PIVOT ARCHITECTURE

ADDENDUM # 5

Project: **Klamath Community College Childcare Learning Center (2331.00)**

Date: September 4, 2025

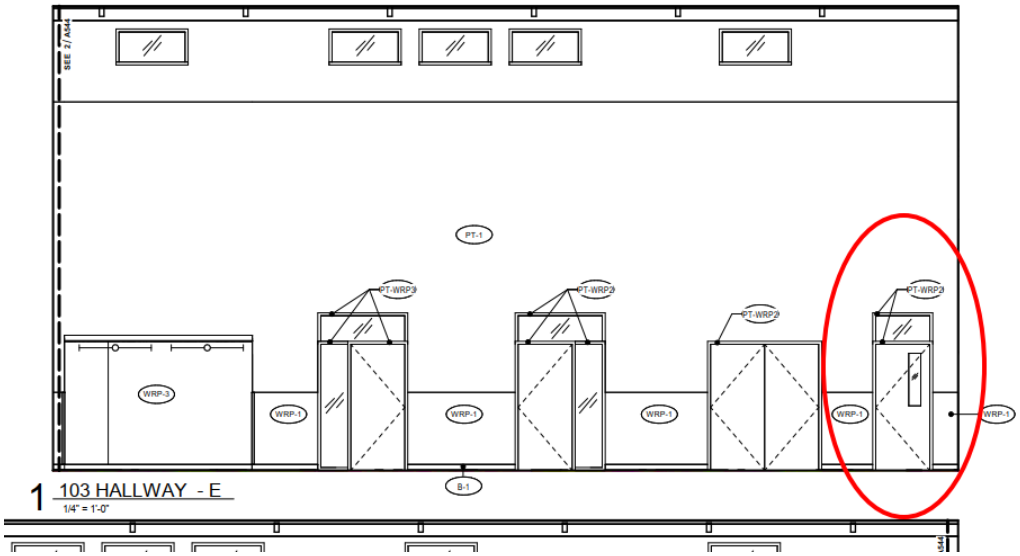
6.9. **Question:** Missing a hollow metal frame type. Circled below.

6.9.1. **Response:** Window type added in Addendum 4. See sheet A620 – Door and Louver Information.

C201

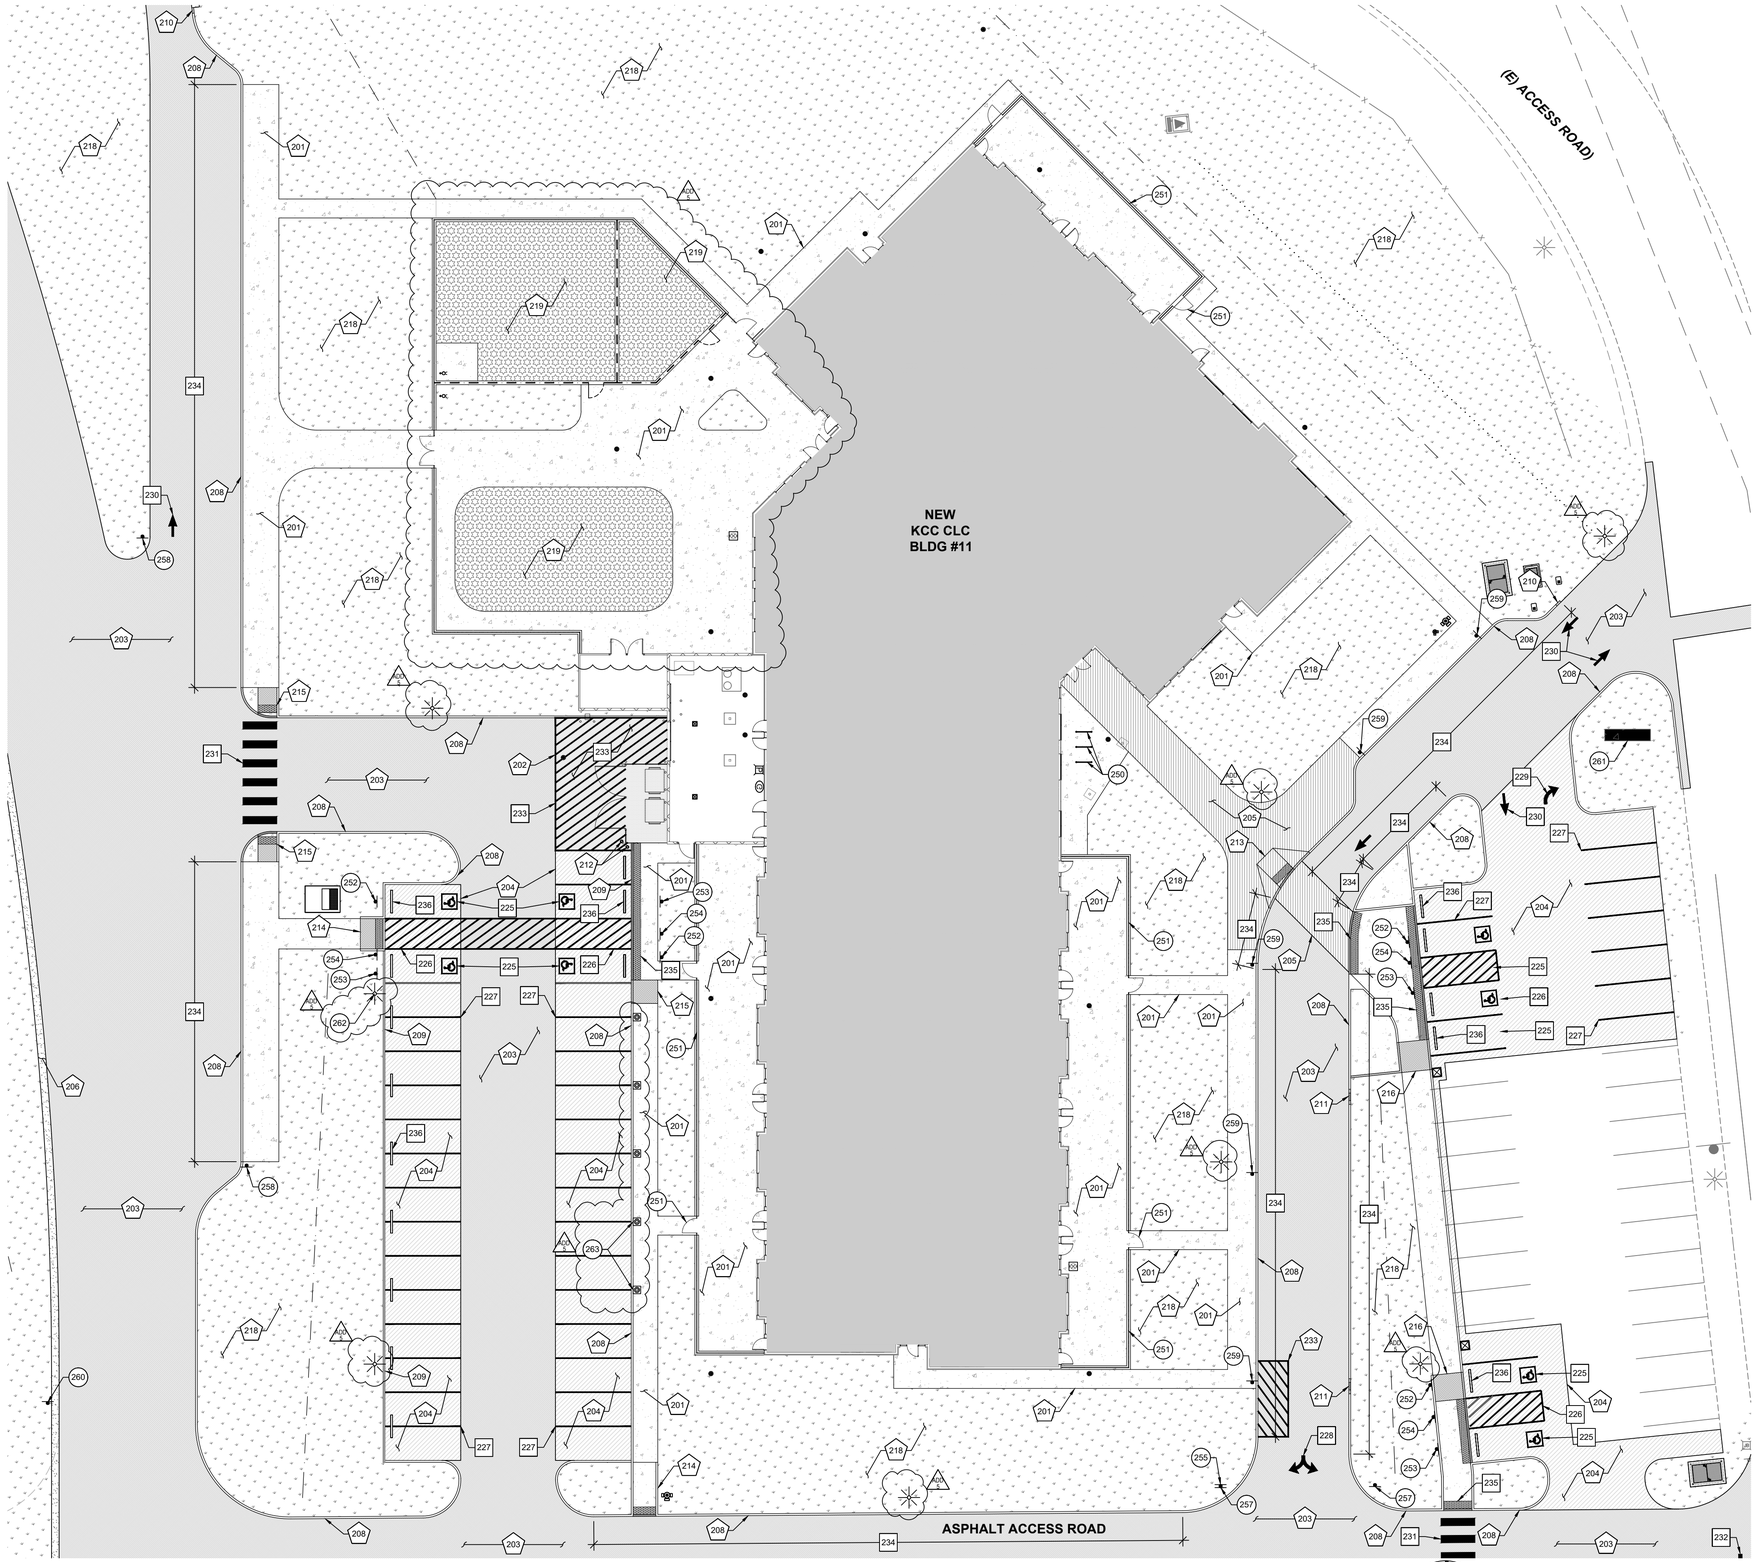
3.1. C201 CLC SITE PLAN

3.1.1. – Revised playground configuration

3.1.2. – Parking lot light locations and note added

3.1.3. – Future EV charging locations and note added

1 C401 CLC WATER AND SEWER UTILITIES PLAN

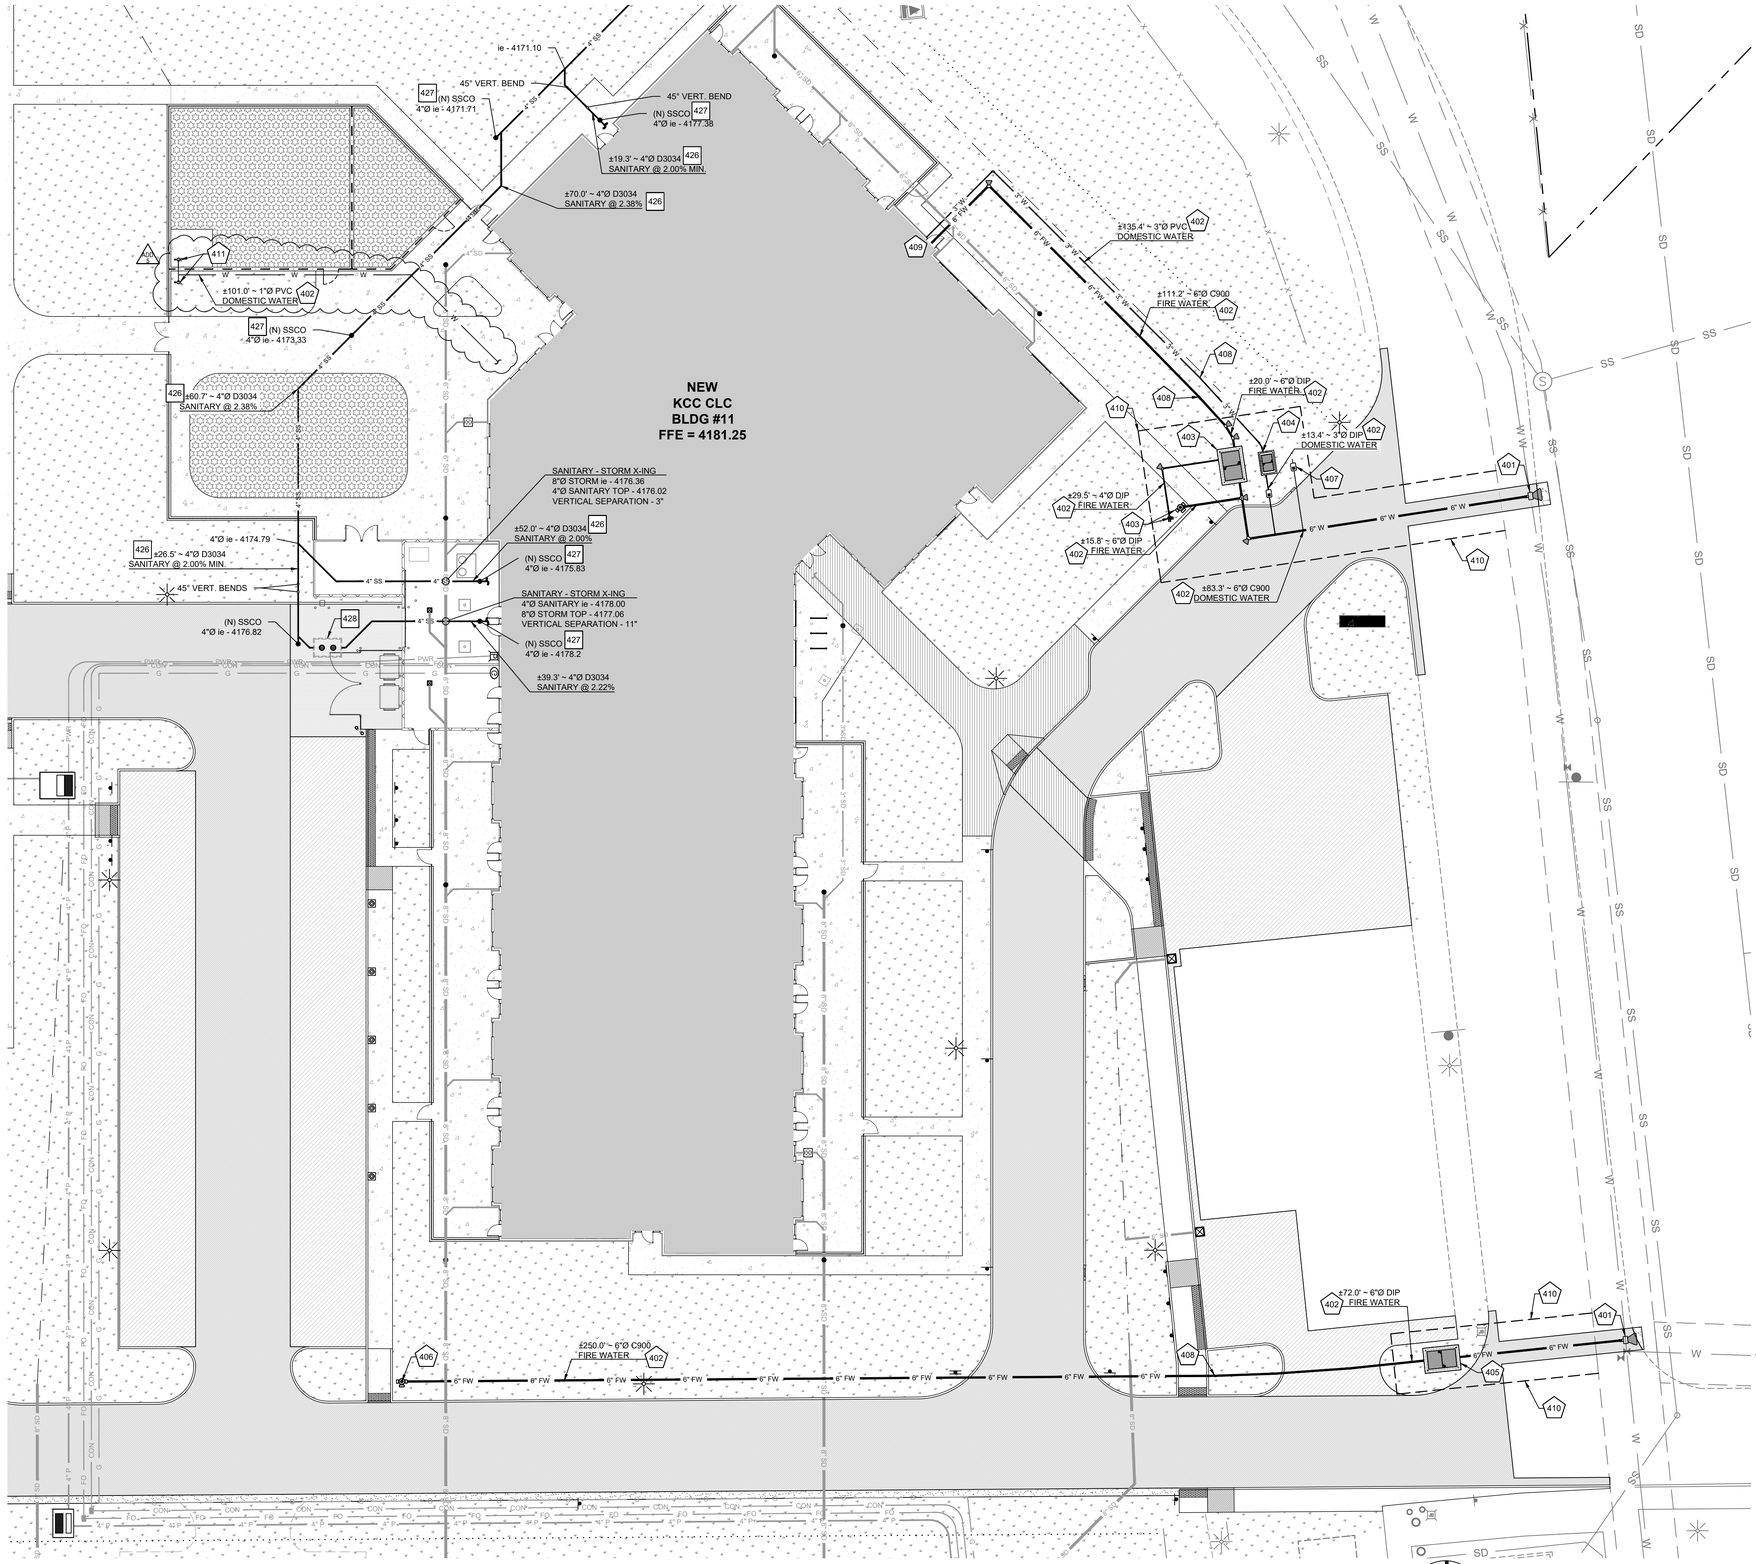
3.2. C401 CLC WATER AND SEWER UTILITIES PLAN

3.2.1. – Freeze-flow yard hydrants (2) and note added

L201

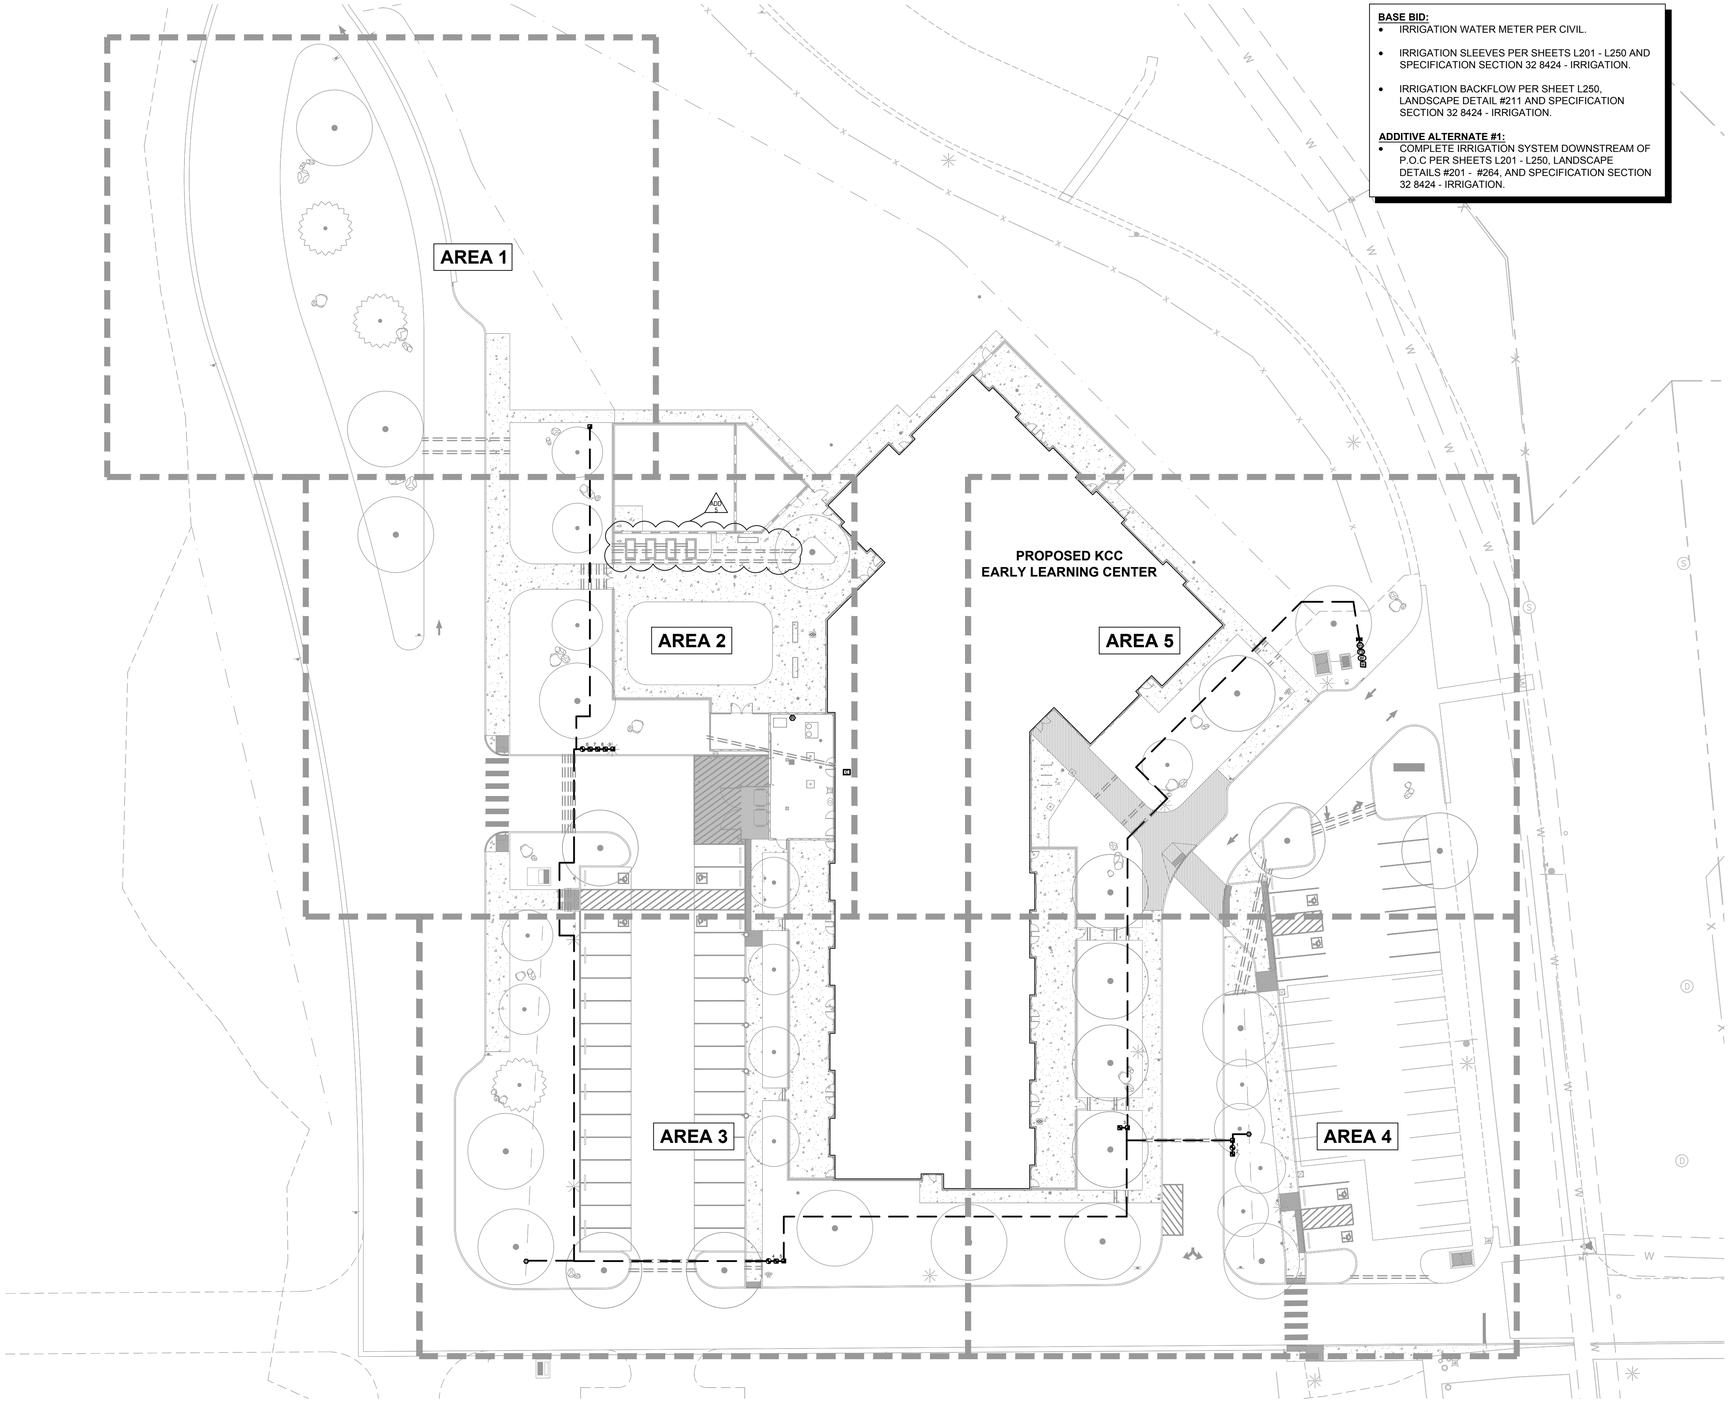
3.4. L201 OVERALL IRRIGATION PLAN & SHEET KEY

3.4.1. – Removed drip irrigation for (1) raised planter box and sleeve in zone 9.

3.4.2. – Added sleeve for lateral pipe in zone 6.

L220

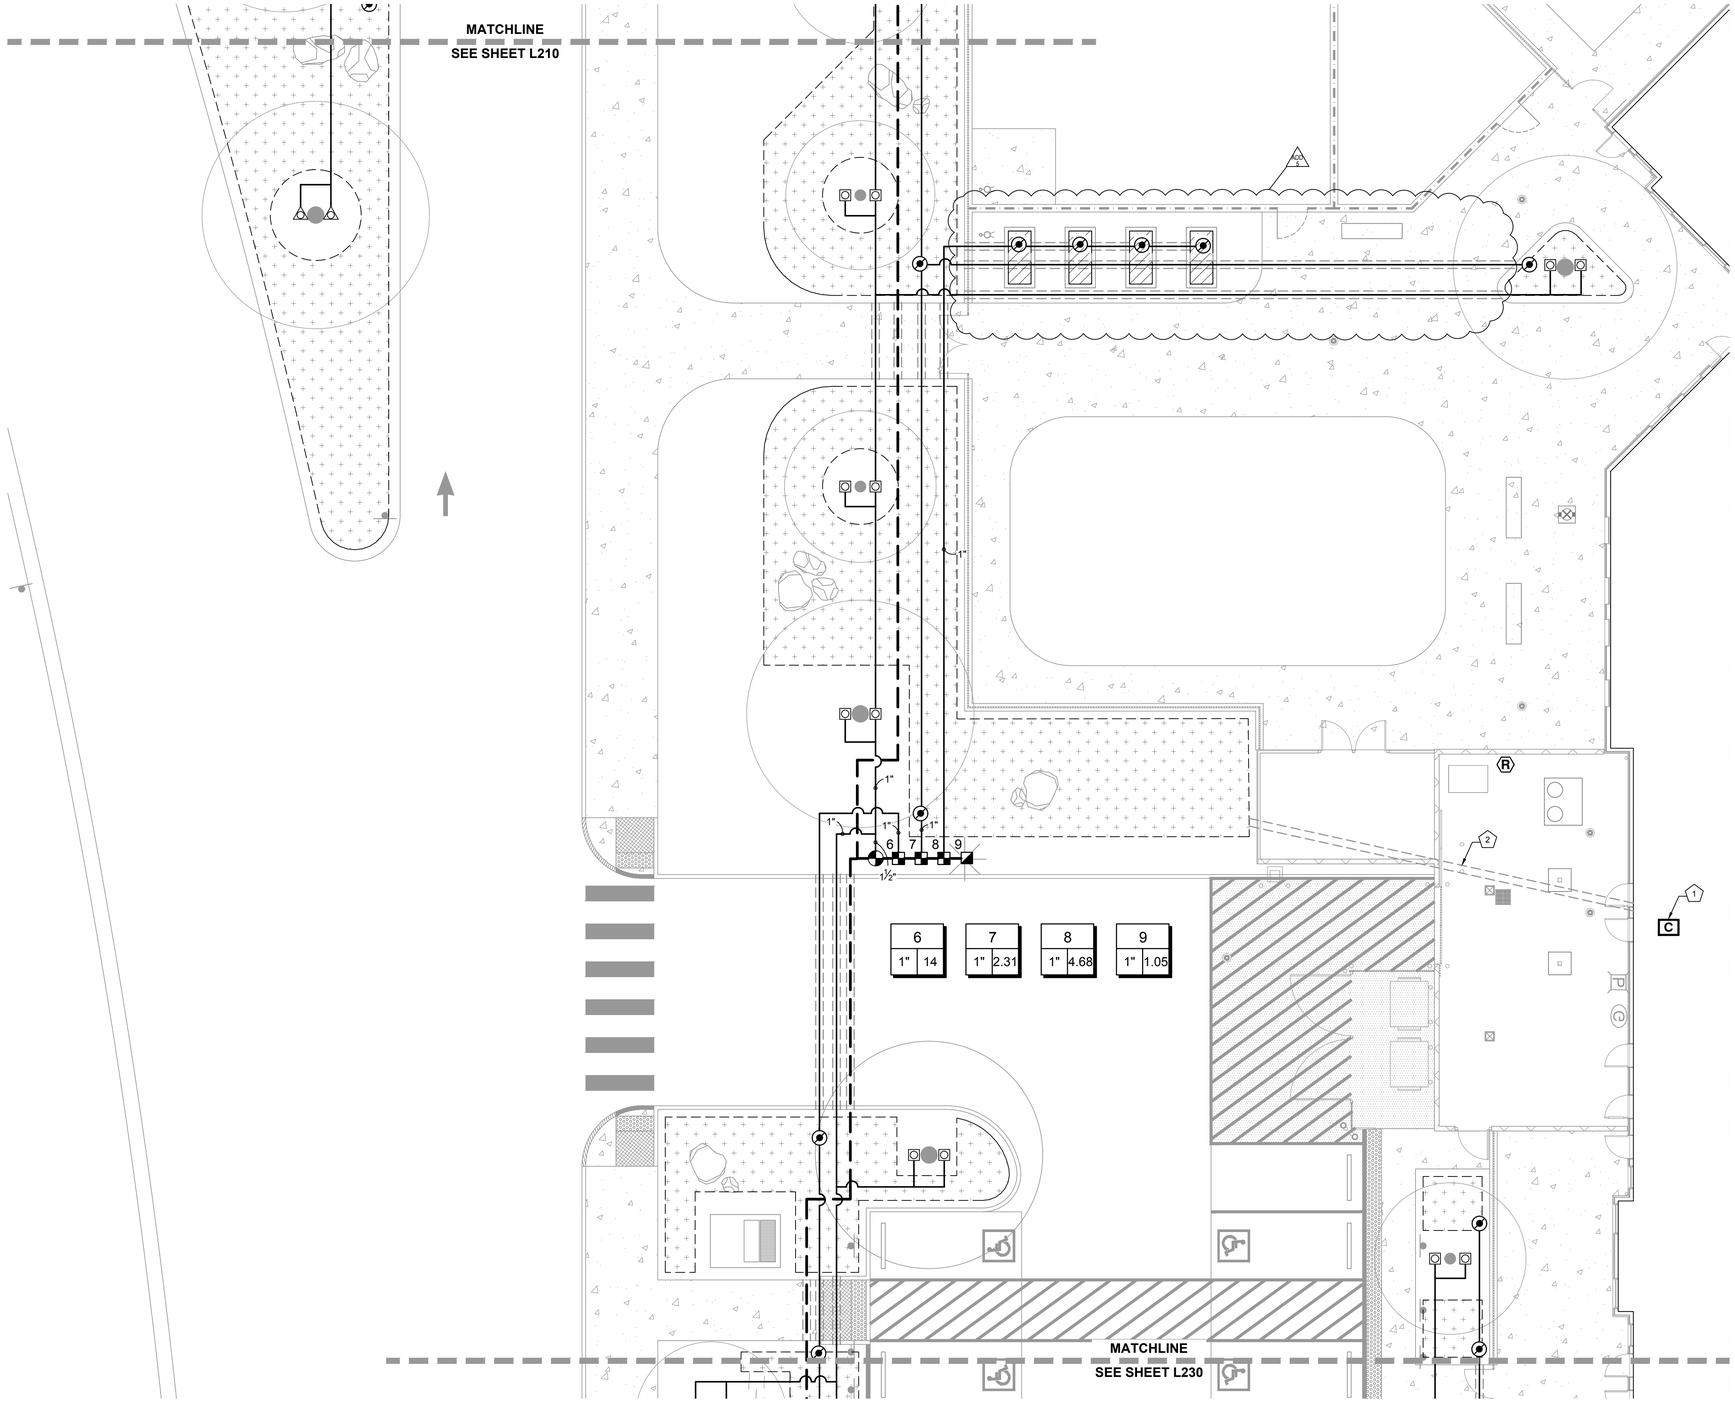
3.5. L220 IRRIGATION PLAN – AREA 2

3.5.1. – Removed drip irrigation for (1) raised planter box and sleeve in zone 9.

3.5.2. Added sleeve for lateral pipe in zone 6.
